RECEIPT DATE: 9/4/14 **ONSITE SEWAGE DISPOSAL SYSTEM** P 554611

PROPERTY ADDRESS: 5942 Clifton Oaks Road

RE: Plot Plan – Building Permit #B13003772
5942 Clifton Oaks Dr.

RE: **5492 Clifton Oaks Drive, Columbel residence, BAT Plan comment**

SEPTIC SYSTEM PROFILE

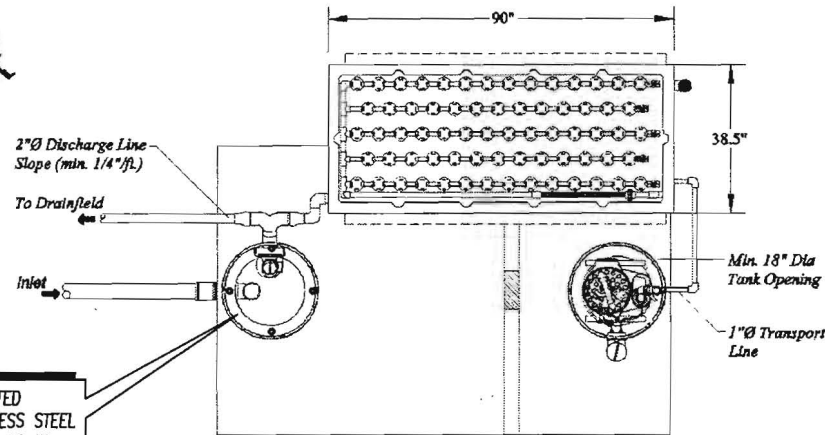
4. In the SHC, the cleanout at the second bend, the third cleanout can be deleted.
5. The primary treatment tank, the septic tank is greater than 3 feet from proposed grade to the top of the tank AND the proposal is to install it at an elevation above "existing grade", i.e. install the tank in 'fill'. County Code [3.810(D)(12)] states that the depth to the top of the tank shall be no more than 3 feet. Due to the weight of the tank and the solution that will fill it, it is inappropriate to set a tank in unconsolidated materials. The tank needs to be set on consolidated earth, or in a manner designated by the tank manufacturer.

As it appears unlikely that the proposed grade will be lowered, the following information is required for the Bureau's approval of the septic tank installation in unconsolidated earth materials.

- a. A copy of a letter from the septic tank manufacturer, on the manufacturer's letterhead, stating the requirements and procedures by which a base may be prepared for the tank and the stabilization of the tank on that base.
- b. A copy of a letter from the BAT unit manufacturer (ORENCO) referring to the diagram for installation at the proposed location, and authorizing installation of the Advantex treatment unit in the illustrated conditions. The letter should specifically approve the installation of the Advantex treatment unit on a septic tank that is installed in unconsolidated earth materials prepared according to the septic tank manufacturers specifications. The BAT manufacturer's letter should also describe the limitation of depth for the treatment unit and stepwise procedures for preparing the site and installing the unit with a riser to proposed grade.

Also, please note that the profile of the sewage treatment system has been revised, so that the septic tank will not be deeper than 3 feet vertically from finished grade. Also attached is a copy of the request for a variance to allow the septic tank to be located 10 feet from the proposed basement of the house. The original request is being simultaneously submitted to Mike Davis. By locating the septic tank and treatment system at this location, we are assured that it will be placed in an area where there has been a controlled fill. Attached you will find a certification from the geotechnical engineer regarding the controlled fill operation.

AdvanTex® AX20 Mode 3A w/Concrete Tank - Maryland 4 Bedroom WITH ANTI-FLOTATION FLANGE

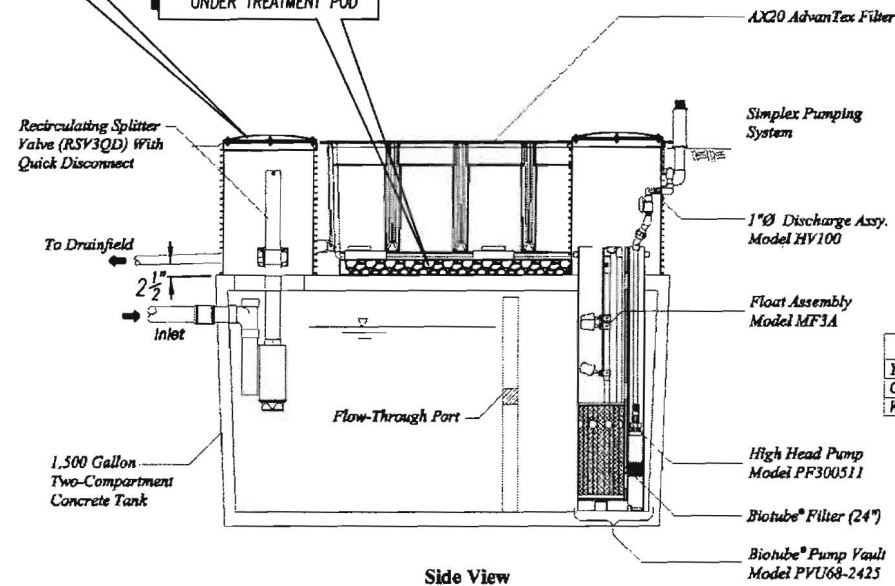
- The Advantex AX20 specifications are not shown on the plan. Please provide the tank pump/tank detail.
- Include the required general notes per the Best Available Technology Site Plan Requirements.
